ATTN: Document Control Desk
U.S. Nuclear Regulatory Commission
Washington, DC 20555-001SUBJECT:
Perry Nuclear Power Plant
Docket No. 50-440, License No. NPF-58
Completion of Required Action by NRC Order EA-12-051, Reliable Spent Fuel Pool
Instrumentation (TAC No. MF0802)

NRC Requests for Information
Page 1 of 23

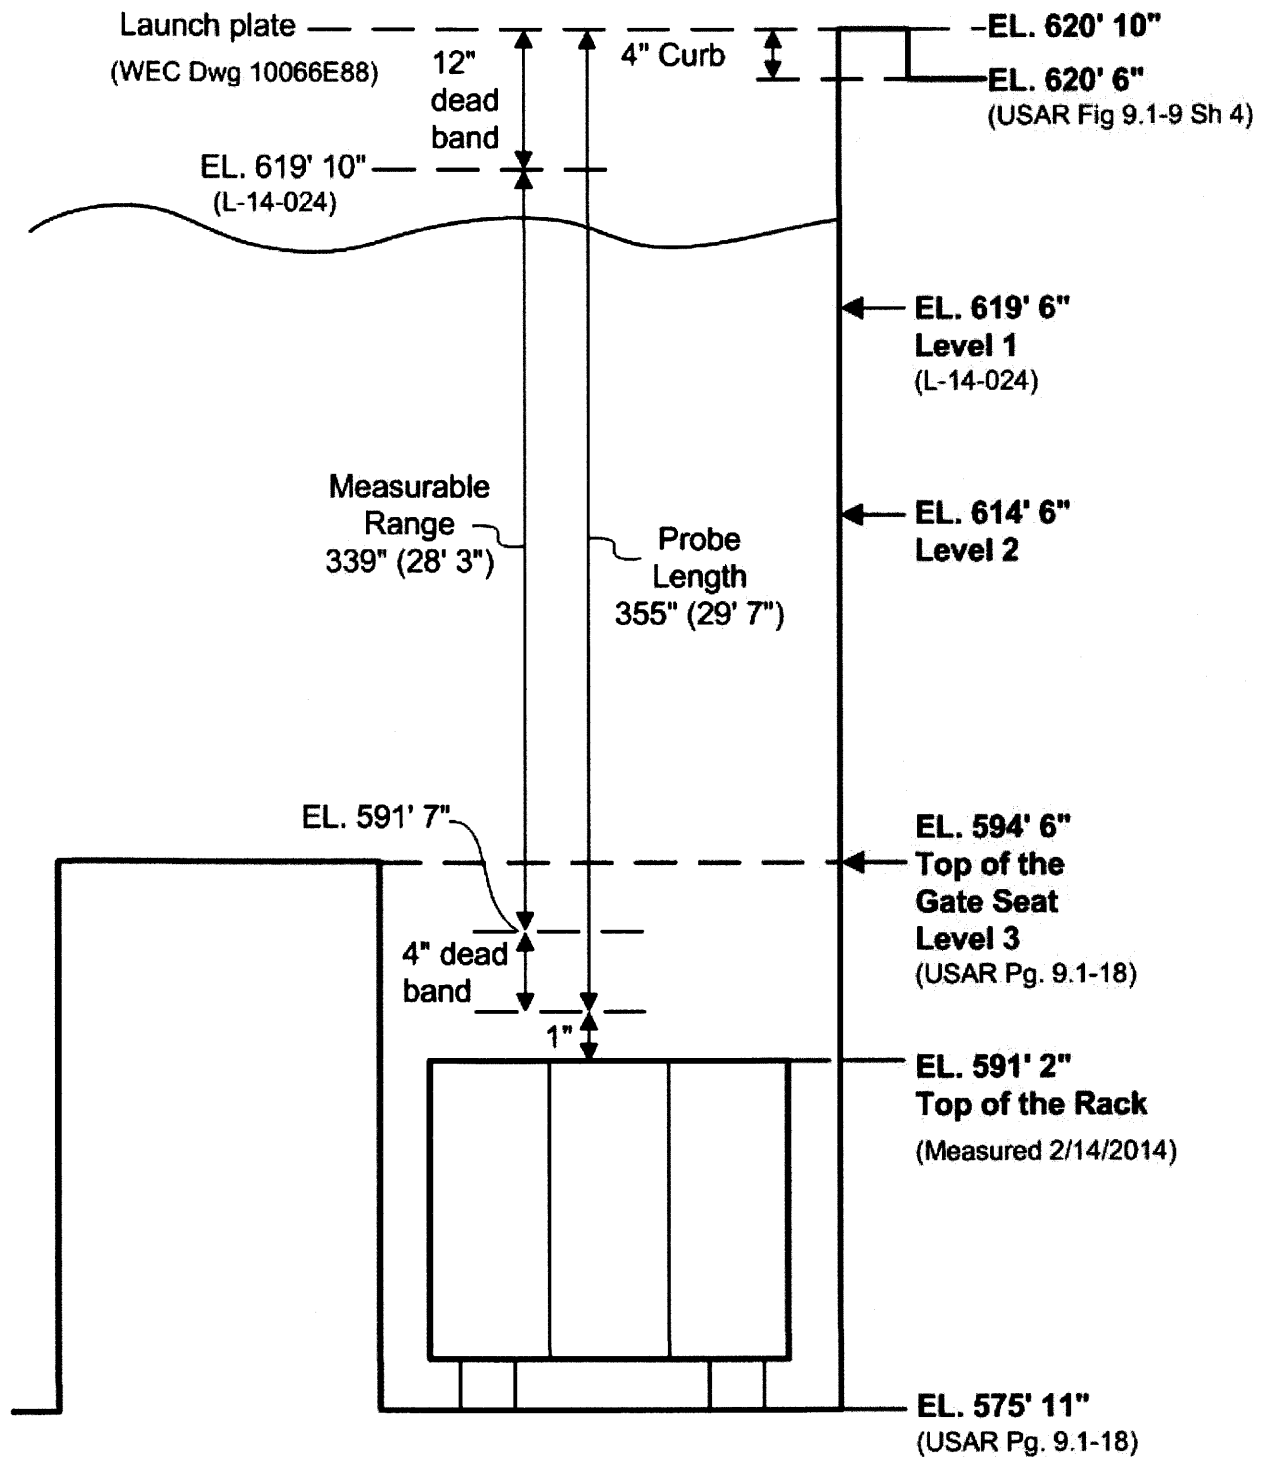
RAI-1:

Please provide a clearly labeled sketch depicting the elevation view of the proposed typical mounting arrangement for the portions of the instrument channel consisting of permanent measurement channel equipment (e.g., fixed level sensors and/or stilling wells, and mounting brackets). Indicate on this sketch the datum values representing Level 1, Level 2, and Level 3, as well as the top of the fuel racks. Indicate on this sketch the portion of the level sensor measurement range that is sensitive to measurement of the fuel pool level, with respect to the Level 1, Level 2, and Level 3, datum points.

Response:

By letter dated February 27, 2014, FENOC provided a sketch depicting the requested datum values. Subsequently, by FENOC letter dated August 28, 2014, Level 2 was changed. An updated sketch is provided below.
